LCA 147
 Attachment A
 Page 1 of 6

FIGURE 3.4-2 REACTOR COOLANT SYSTEM PRESSURE — TEMPERATURE LIMITS VERSUS 60°F/HOUR HEATUP RATE — CRITICALITY LIMIT AND HYDROSTATIC TEST LIMIT

8611050386 861031
 PDR ADDCK 05000344
 P PDR

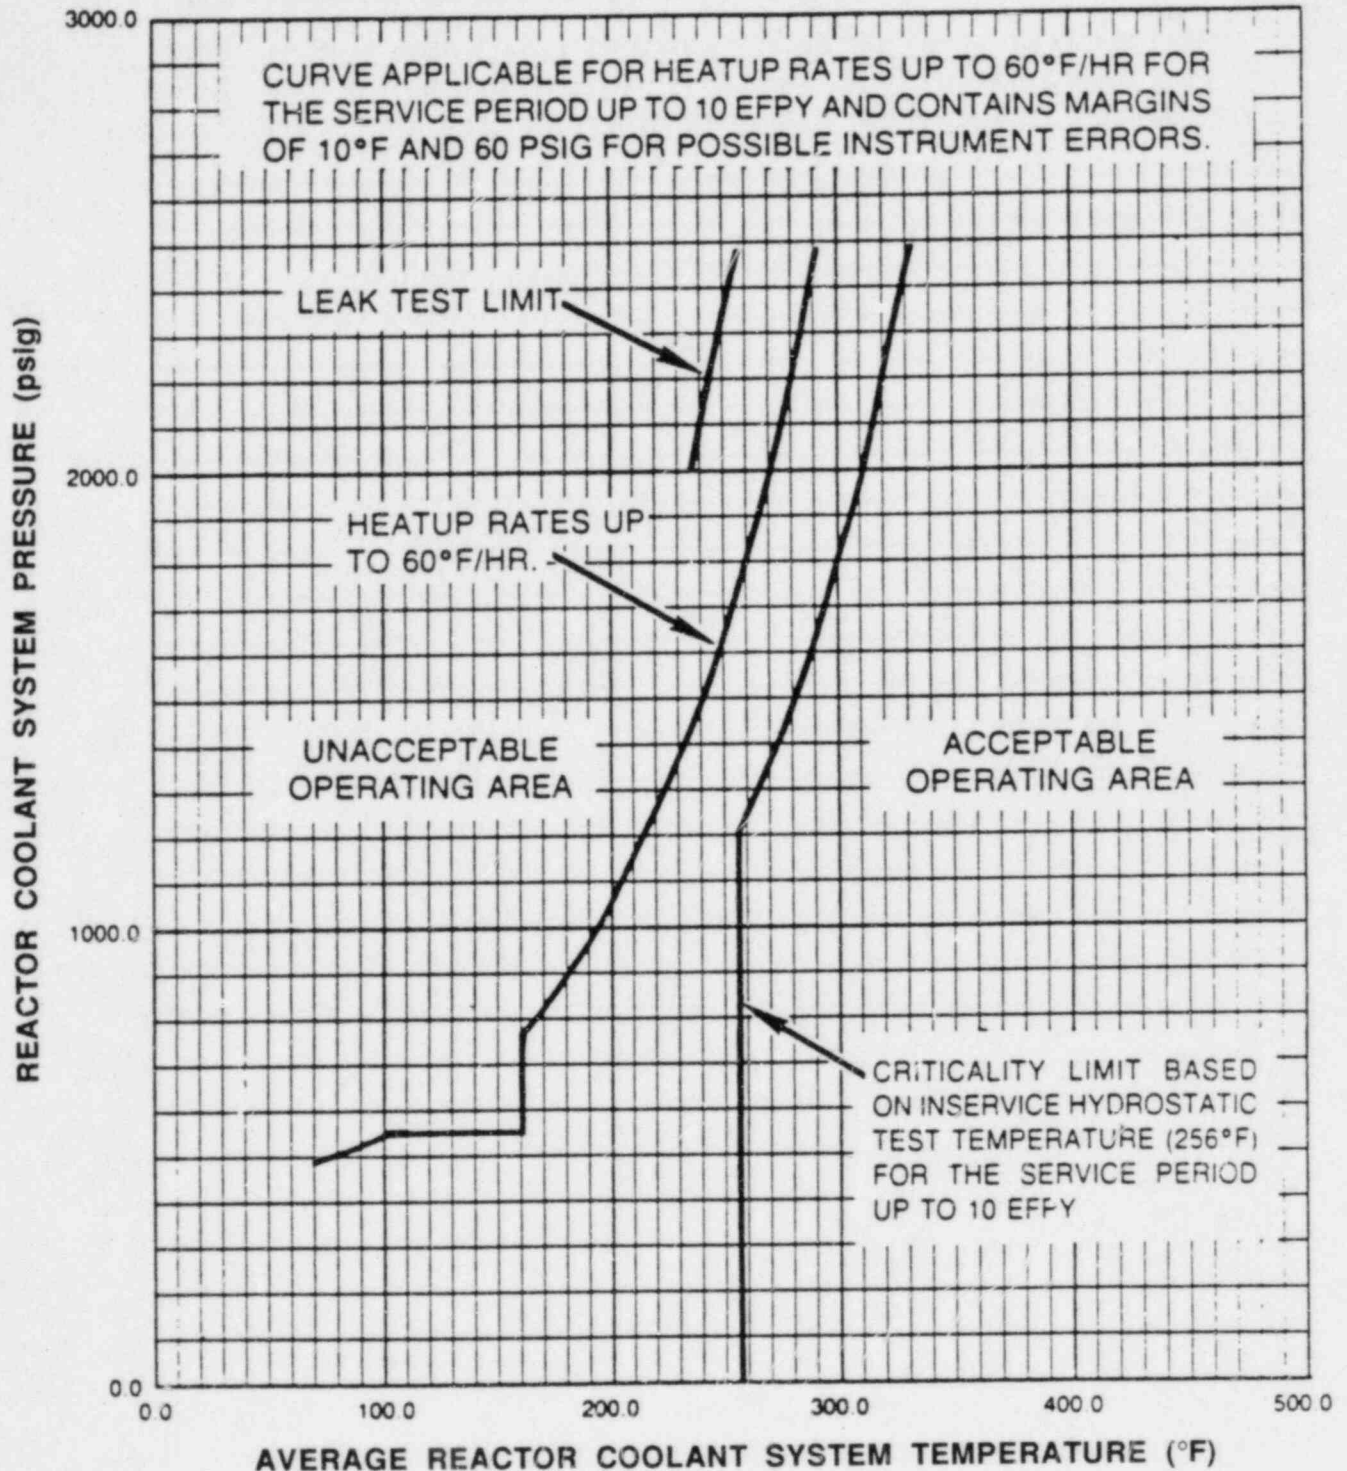
CONTROLLING MATERIAL : R.V. LOWER SHELL
 COPPER CONTENT : 0.16 WT%
 PHOSPHORUS CONTENT : 0.012 WT%
 INITIAL RT_{NOT} : 10°F
 RT_{NOT} AFTER 10 EFY : ¼T, 111°F
 : ¾T, 55°F

The heatup limit curve, Figure 3.4-2, is a composite curve which was prepared by determining the most conservative case, with either the inside or outside wall controlling, for any heatup rate up to 60°F per hour. The cooldown limit curves Figure 3.4-3 are composite curves which were prepared based upon the same type analysis with the exception that the controlling location is always the inside wall where the cooldown thermal gradients tend to produce tensile stresses while producing compressive stresses at the outside wall. The heatup and cooldown curves were prepared based upon the most limiting value of the predicted adjusted reference temperature at the end of 10 EFPY and reflect the analysis of Capsule X contained in WCAP-10861.

**FIGURE 3.4-3 REACTOR COOLANT SYSTEM PRESSURE —
TEMPERATURE LIMITS VERSUS
COOLDOWN RATES**

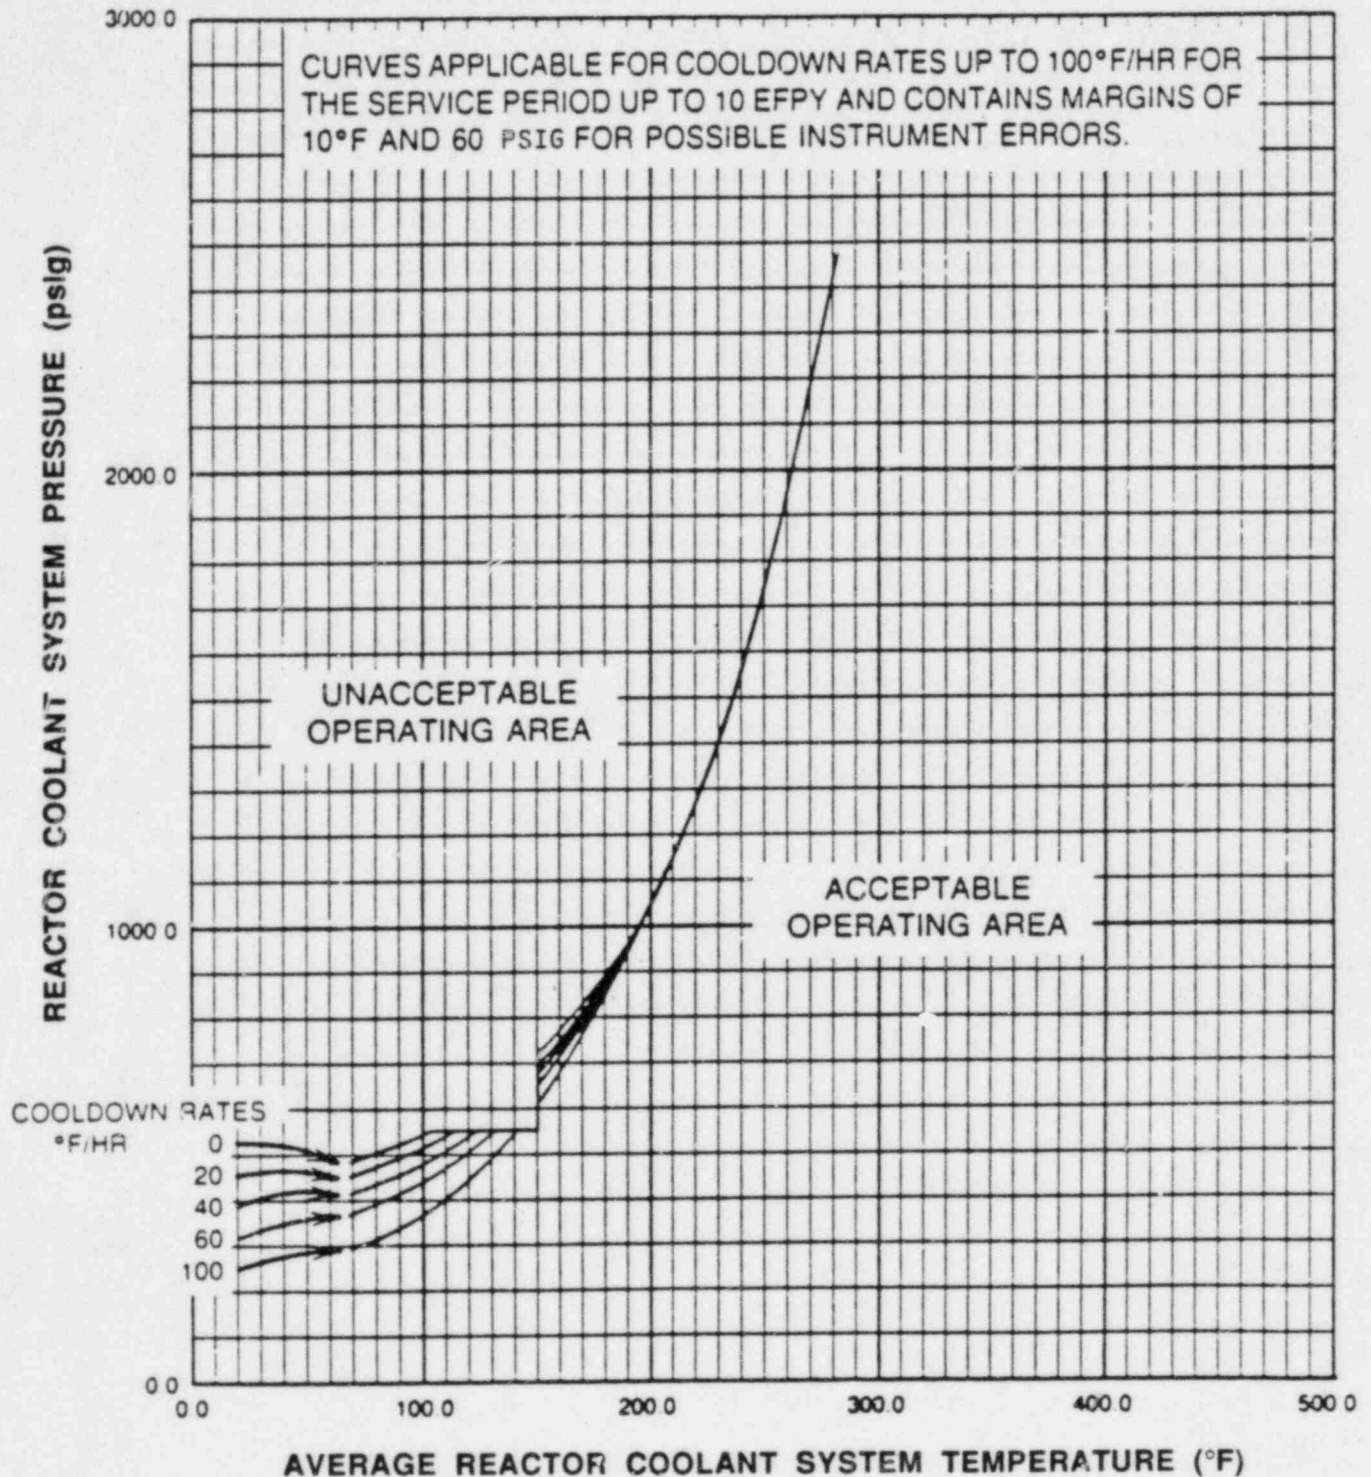
CONTROLLING MATERIAL : R.V. LOWER SHELL

COPPER CONTENT : 0.16 WT%

PHOSPHORUS CONTENT : 0.012 WT%

INITIAL RT_{NDT} : 10°F

RT_{NDT} AFTER 10 EFPY : 1/4 T, 111°F

: 3/4 T, 55°F
